RE: 120 Oak Meadow Drive

I reviewed the drawings and evaluated the site context. My comments and recommendations are as follows:

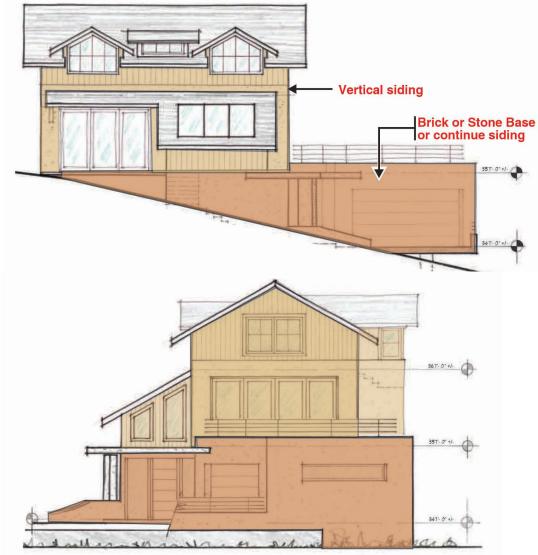
1. The large amount of stucco compared to the proposed vertical siding would be out of character to this neighborhood and not consistent with Residential Design Guideline 3.8.2. There are many types of materials in the neighborhood structures; plaster among them like the building across the street.

Large amount of stucco would be out of character with this neighborhood and not consistent with Residential Design Guideline 3.8.2

• One way of fitting a new house into an existing neighborhood - especially if the new house is bigger than many of the others around it - is to use materials drawn from the surrounding neighborhood. An all stucco house might seem out of character in an all wood neighborhood, but the predominant use of wood siding with some elements of stucco can often work. Where stone accents (e.g., chimneys) are common in a neighborhood, the use of stone at the wall base and elsewhere can assist in making the new home seem better connected to its surroundings. Stone is not an appropriate application for this. A good portion of the driveway and garage float like a bridge to protect the tree root zones. Stone does not 'Float'.

- 1. Reduce the large amount of stucco on the house by extending the vertical siding consistently down to the first floor line. **See prior response.**
- 2. Use brick or stone for the building base below the first floor line or continue the use of vertical siding in this area. The adjacent existing home on this larger parcel has a prominent brick base see photo below. If brick or stone is used, provide a projecting brick or stone ledge at the transition with any vertical sid-ing. If vertical siding is used, add a horizontal belly band to break up taller wall planes. Horizontal belly band is not appropriate for this home. If we were transitioning from one wood above and another type of wood below, then a belly band might be appropriate, but ours is not the case. In this case, a belly band is not warranted or desirable.

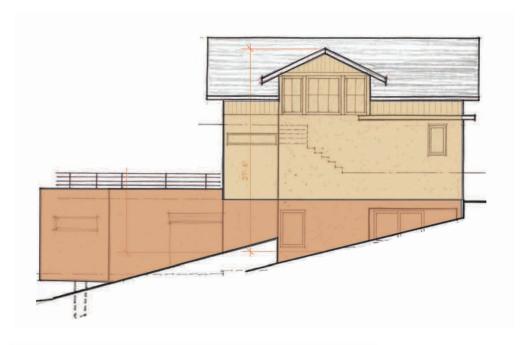
- 2. The small areas of wood siding on the front and rear elevations is awkward, and the materials change in the same plane which would not be consistent with Residential Design Guideline 3.8.4.
 - 3.8.4 Materials changes The location of the material is consistent with the style of this house, which is mountain rustic/farmhouse.
 - Make materials and color changes at inside corners rather than outside corners to avoid a pasted on look.
